Multiplex for  
UNSW Biological Sciences Project

**S96 (SSD 6674)**  
**Architectural Design Statement**

27 October 2016

Fig. 5 - Proposed Amended Building Form (Aerial view from northwest)

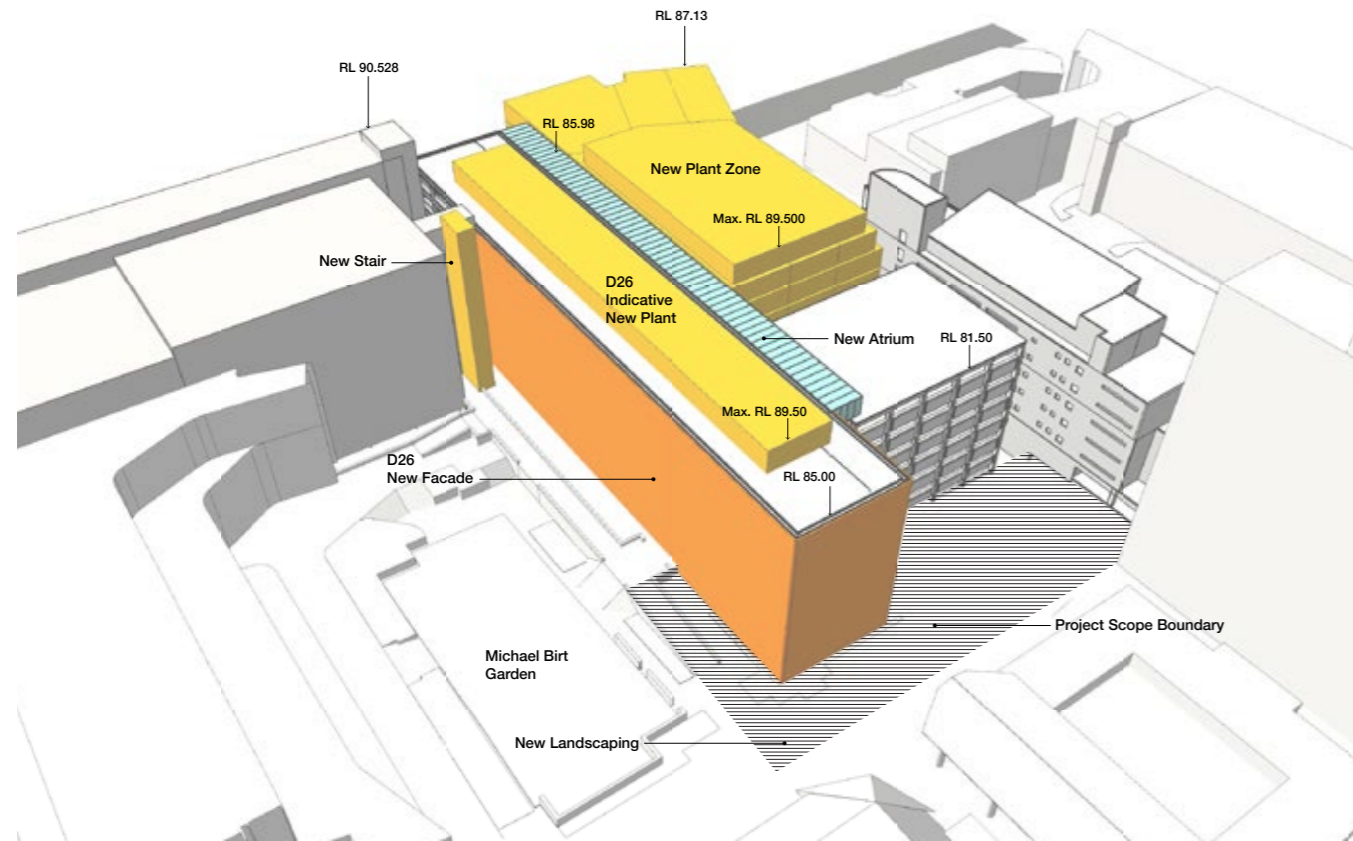
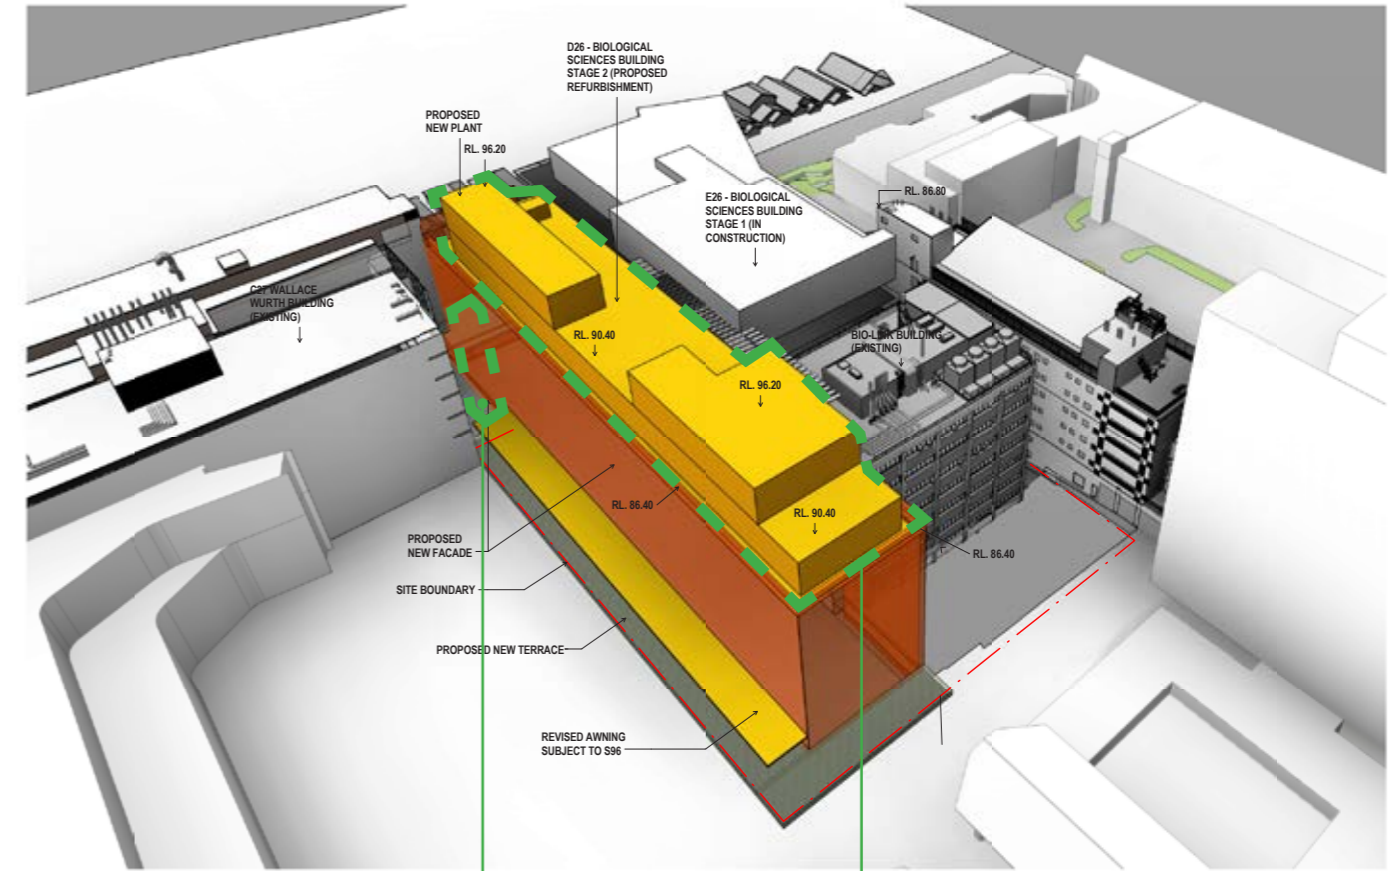
The amendments to the Building Form proposed are to the Level 7 and 8 Plant room of Building D26.

As D26 is Stage 2 of the works, the project has undergone a Brief and Design development since the consented scheme was approved in August 2015. The evolution has resulted in a more detailed understanding of the building program and services strategy. As a result the plant is required to have greater area and volume.

The Level 7 Plant now extends close to the building perimeter and with the amount setback and the reduced level from Botany street remaining as per the consented scheme.

Additional part levels to Level 8 contain further plant and are setback from the building edges at the east end west ends to minimise visual impact on Botany Street and

The escape stair previously consented between Wallace Wirth Building and Building D26 is now no longer required and shown as an amendment.

S96: ESCAPE STAIR NO LONGER REQUIRED

S96: PROPOSED AMENDMENTS TO ROOF ENCLOSURE

Fig. 7 - Proposed S96 Building Form (Aerial view from southeast)

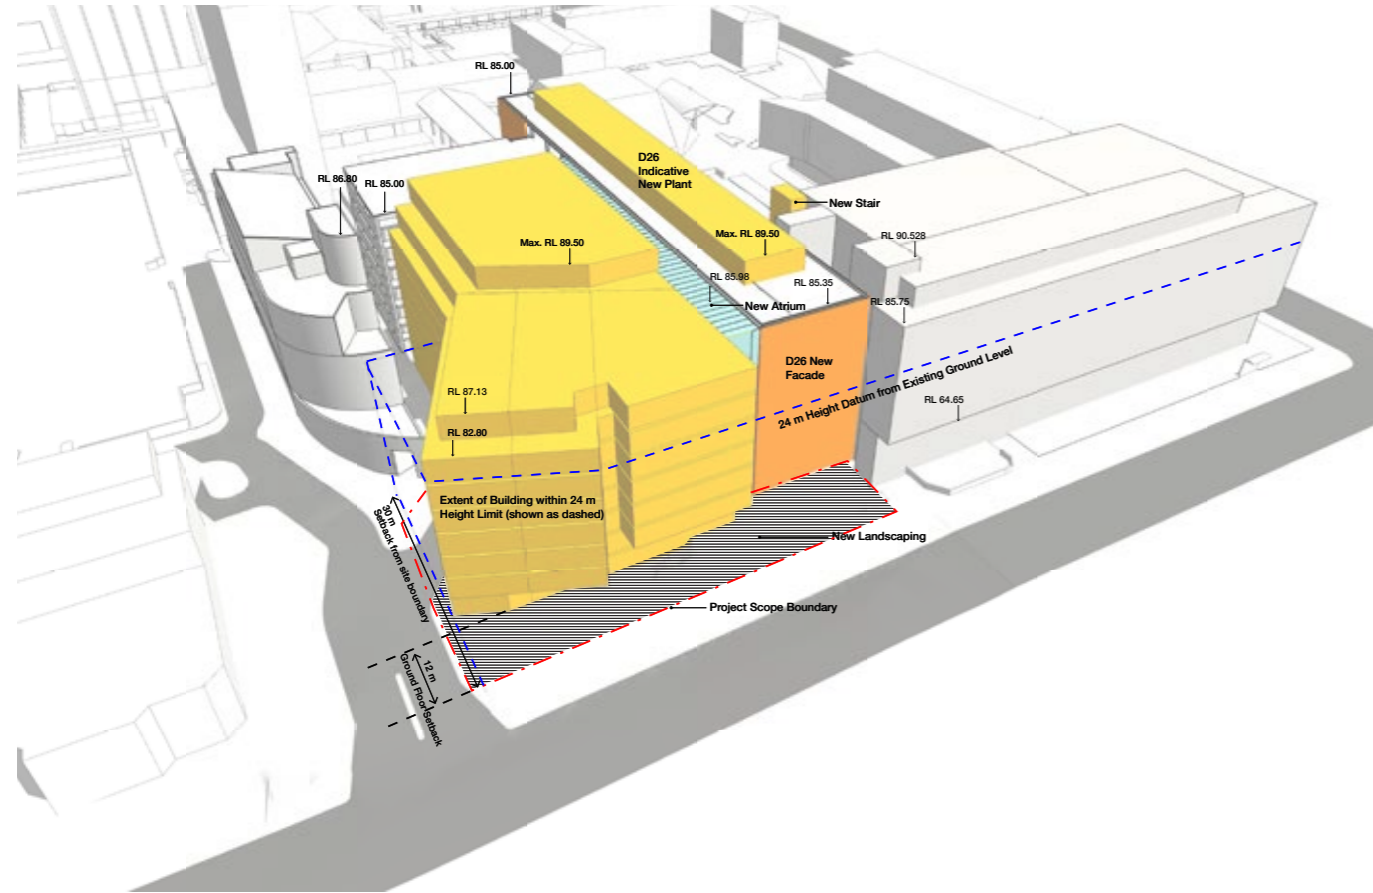
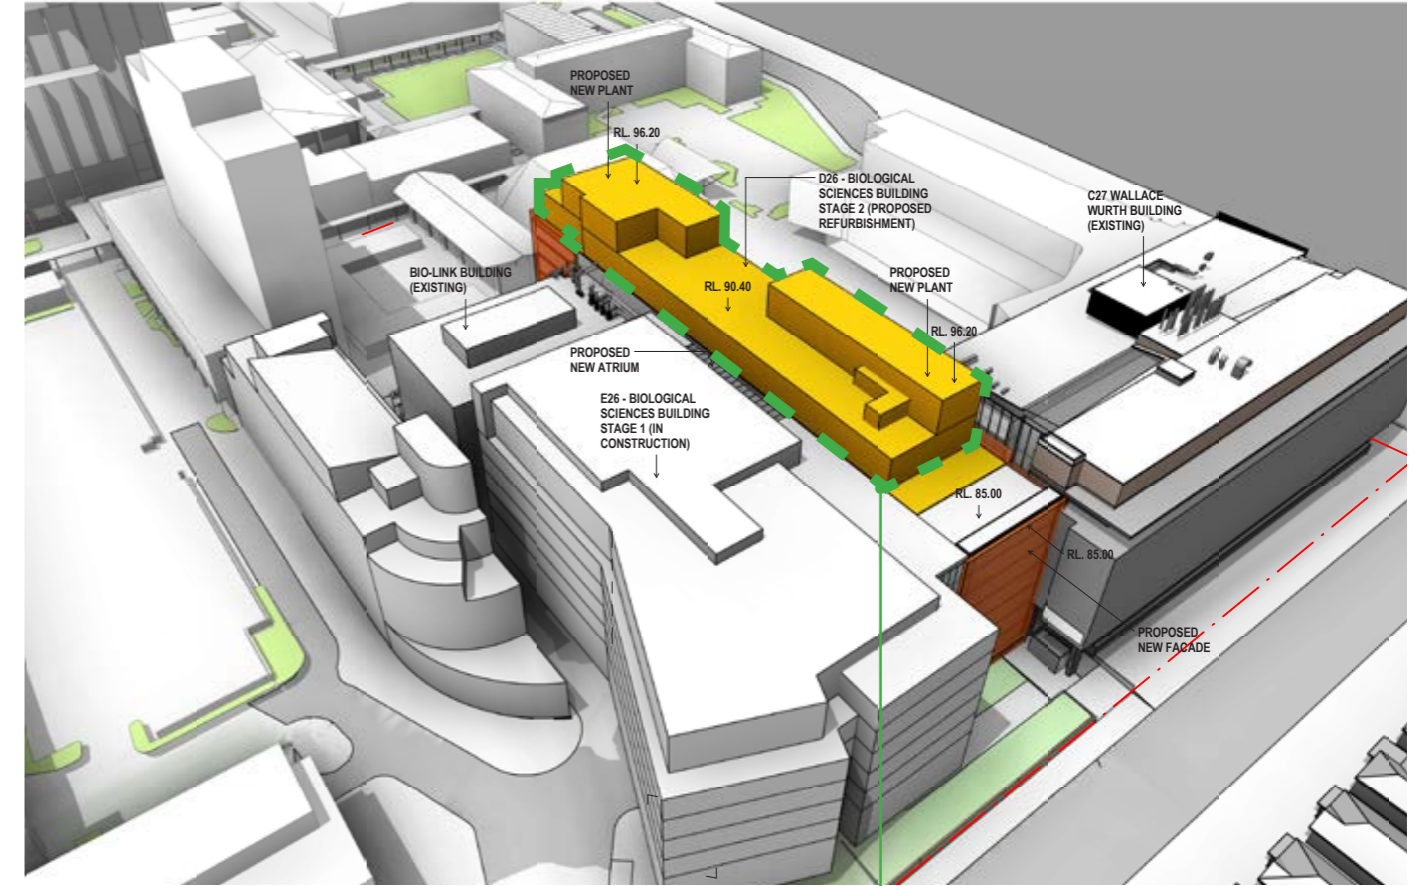
S96: PROPOSED AMENDMENTS TO ROOF ENCLOSURE

Fig. 9 - Proposed S96 Shadow Diagram

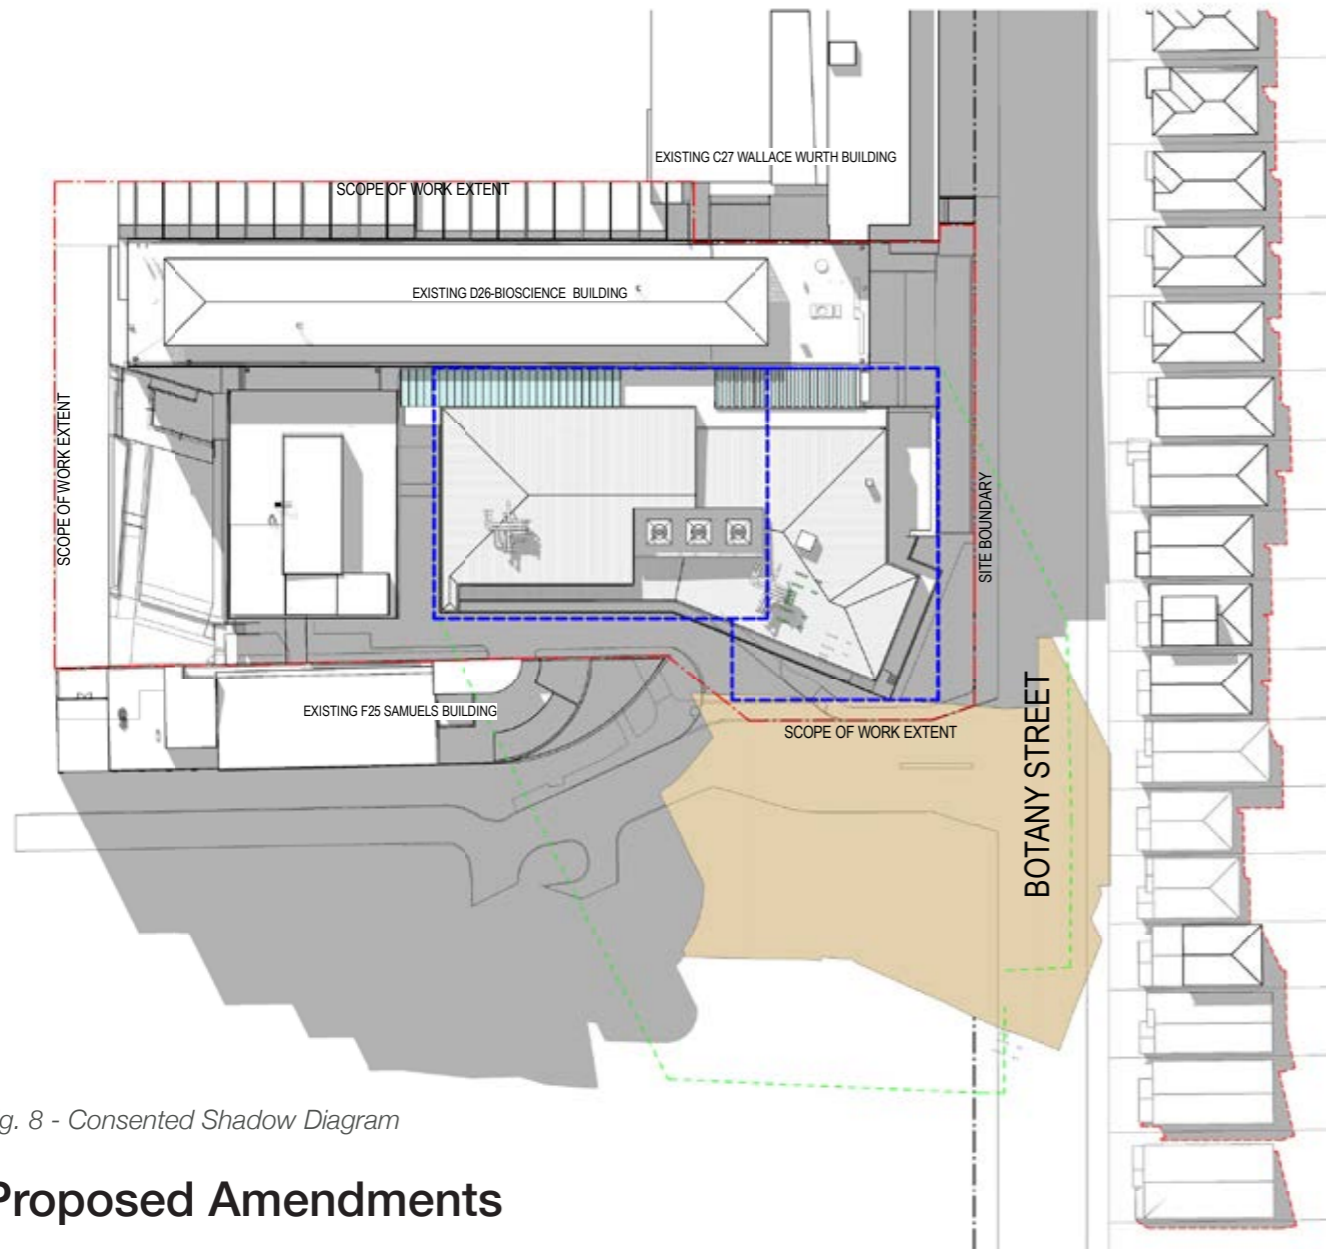
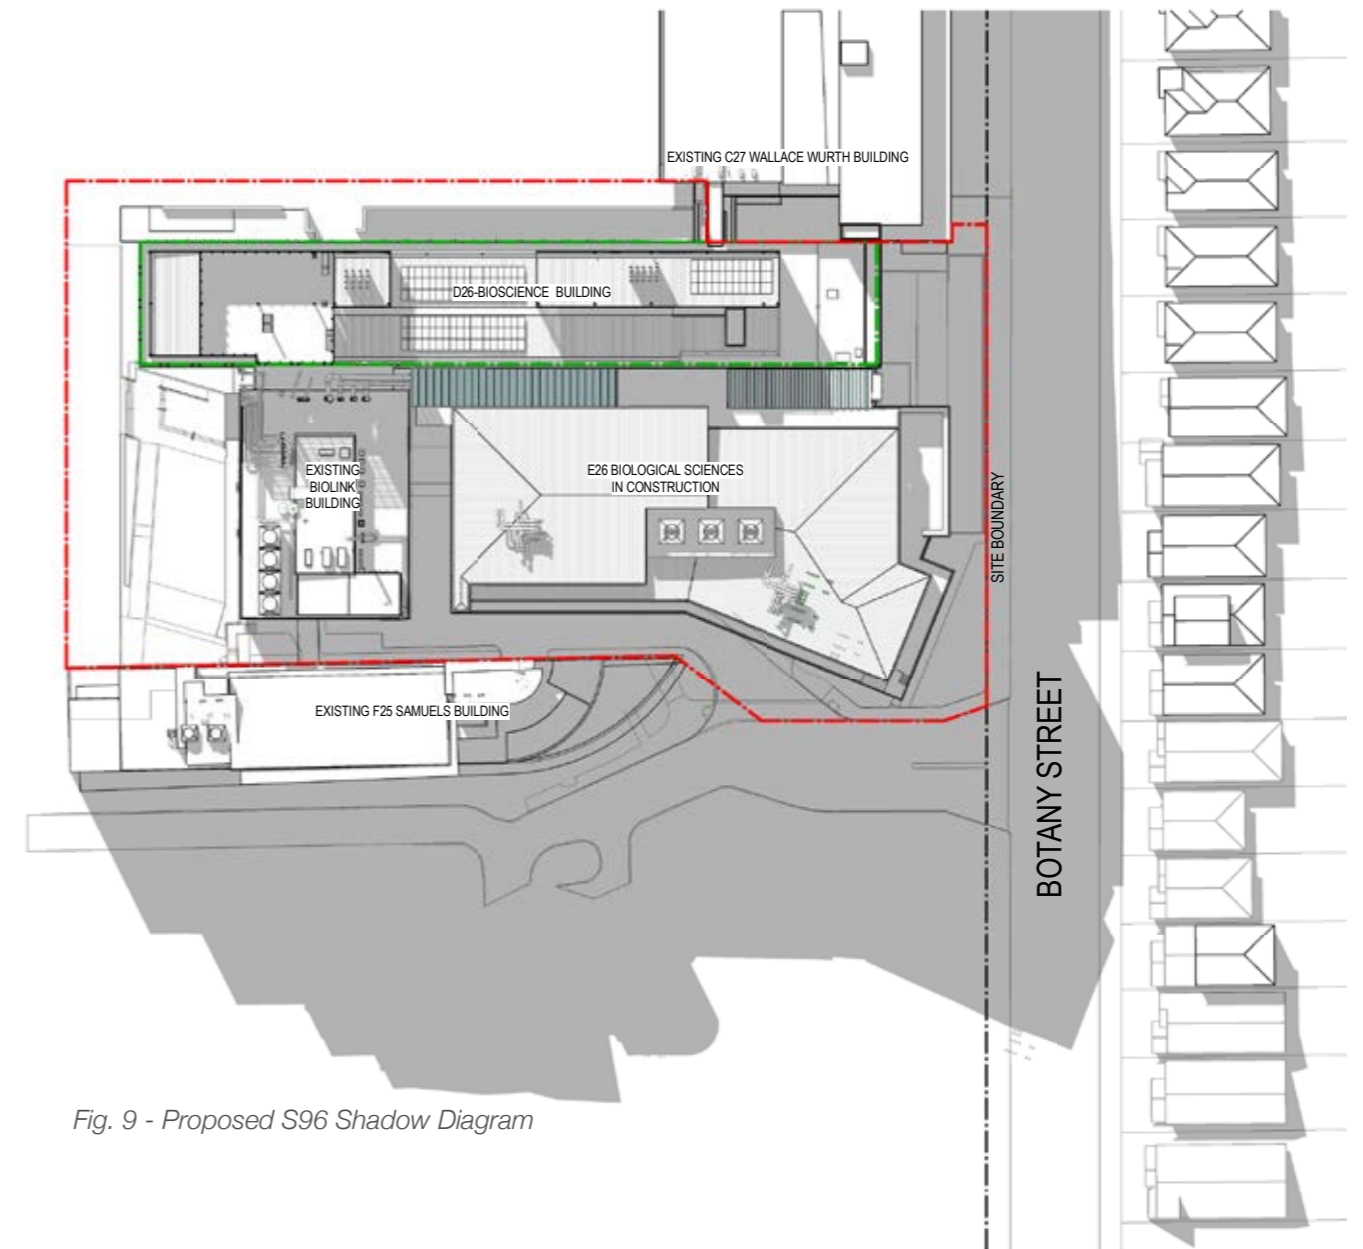
The additional mass at Level 8 to extend the plant room doesn't have any significant impact on the overshadowing of neighbouring buildings as demonstrated in the diagrams above.

Due to the northern location of Building D26 in relation to Building E26, some overshadowing occurs to the northern part of Biolink Building and Building E26.

Fig. 13 - Consented Awning

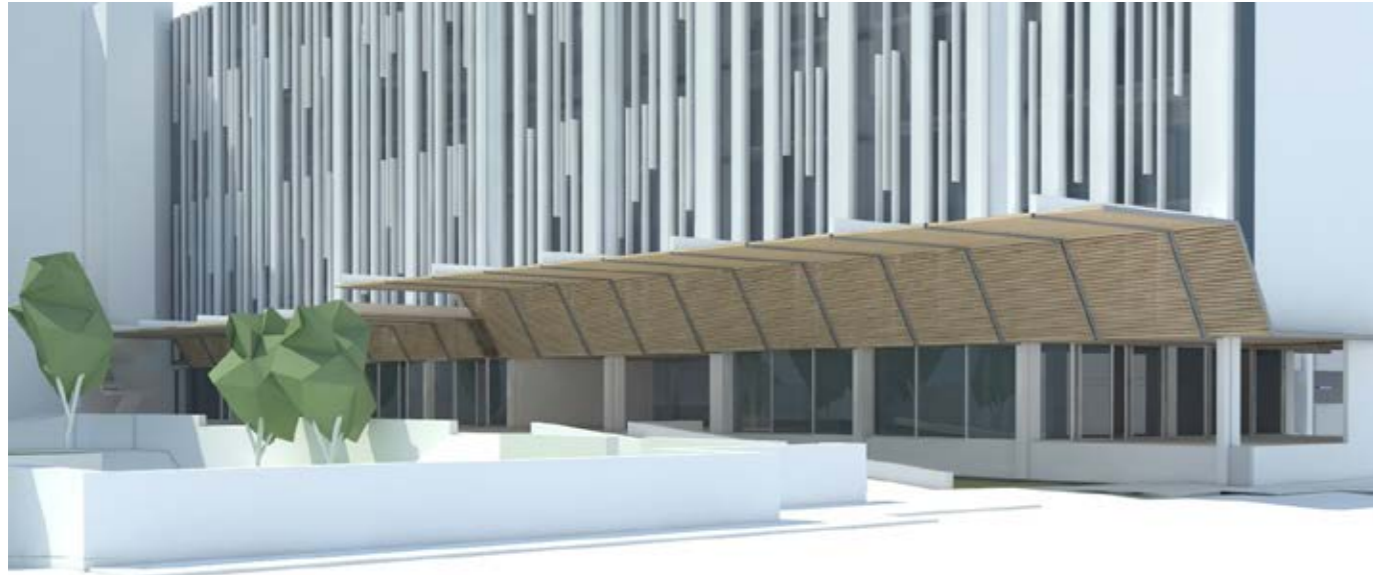
The awning is modified to by lowering the canopy line from top of Level 1 to top of Ground Floor. This provides better shading and weather protection and also provides a more balanced facade composition creating a bottom-middle-top relationship.

The material of awning soffit is proposed to be an aluminium panel and coloured to reference the terracotta found in the E26 facade.

The consented step in the awning is referenced in the proposed amendments through a change in the inclination angle of the awning which is positioned to frame the main entrance.
